TO: HONORABLE CHAIRMAN AND PLANNING COMMISSION
FROM: RON WHISENAND, COMMUNITY DEVELOPMENT DIRECTOR
SUBJECT: TENTATIVE PARCEL MAP PR 06-0166 (APPLICANT: PACKERS)
DATE: MARCH 13, 2007

TO: Darren Nash
FROM: John Falkenstien
SUBJECT: PR 06-0166 Packer
DATE: March 13, 2007

TENTATIVE
PARCEL MAP
PR 06-0166

Exhibit B
Tentative Parcel Map
PR 06-0166
(Packer)

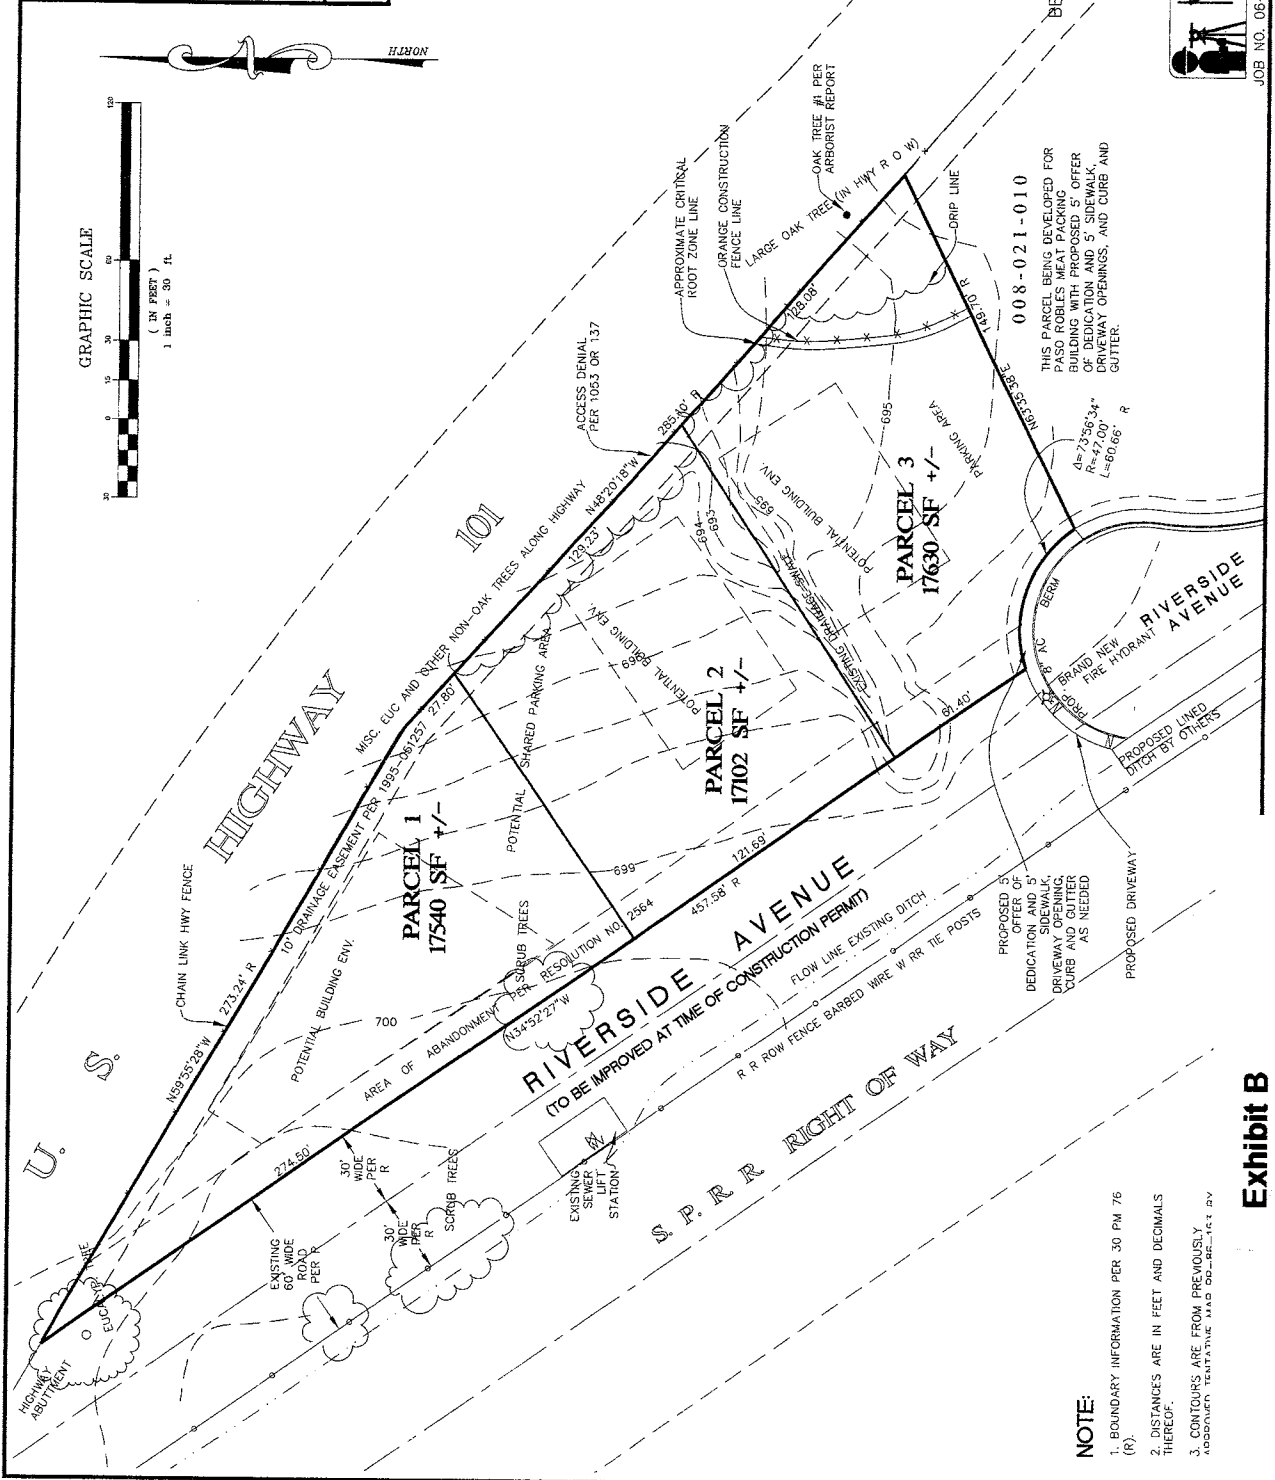
The subject property is located on Riverside Avenue near its northern terminus at Highway 101. Riverside Avenue is a local Industrial Street. A cul-de-sac will need to be developed in accordance with City Standard A-18. A common driveway may be extended northerly from the cul-de-sac in the Riverside Avenue right-of-way to serve each parcel.

There is an 8-inch water main in Riverside Avenue. This water line will have to be extended from the cul-de-sac 300 feet north at the time of development of either Parcel 1 or 2.

An 8-inch sewer line was recently constructed across the frontage of the subject property in order to serve the Dorsey project.

The existing drainage course on the property may ultimately be developed as an open channel or a storm drain along with the development of Parcels 2 and 3. A drainage analysis will be needed to properly size the culvert located under the common driveway.

1. Prior to recordation of the final map, Riverside Avenue shall be finished in a cul-de-sac in accordance with City Standard A-18. Street lights shall be placed on Riverside Avenue in accordance with plans approved by the City Engineer.
2. Prior to occupancy of any building in the subdivision, a private driveway shall be extended to serve Parcel 1 in accordance with plans approved by the City Engineer. The improvements shall include a new storm drain culvert.
3. Prior to issuance of a building permit, an 8-inch water main shall be extended from the cul-de-sac to a point 300 feet north along with placement of a fire hydrant.

5. Prior to recordation of the final map, Riverside Avenue shall be finished in a cul-de-sac in accordance with City Standard A-18. Street lights shall be placed on Riverside Avenue in accordance with plans approved by the City Engineer.

6. Prior to occupancy of any building in the subdivision, a private driveway shall be extended to serve Parcel 1 in accordance with plans approved by the City Engineer. The improvements shall include a new storm drain culvert.

7. Prior to issuance of a building permit, an 8-inch water main shall be extended from the cul-de-sac to a point 300 feet north along with placement of a fire hydrant.
8. Provide fire sprinkler systems for commercial and industrial buildings.
9. Prior to start of construction, documentation shall be submitted to Emergency Services showing that the required fire flows can be provided to meet all project demands.
10. Provide an approved road to serve all three parcels or an approved turn around at the North end of Parcel 1.
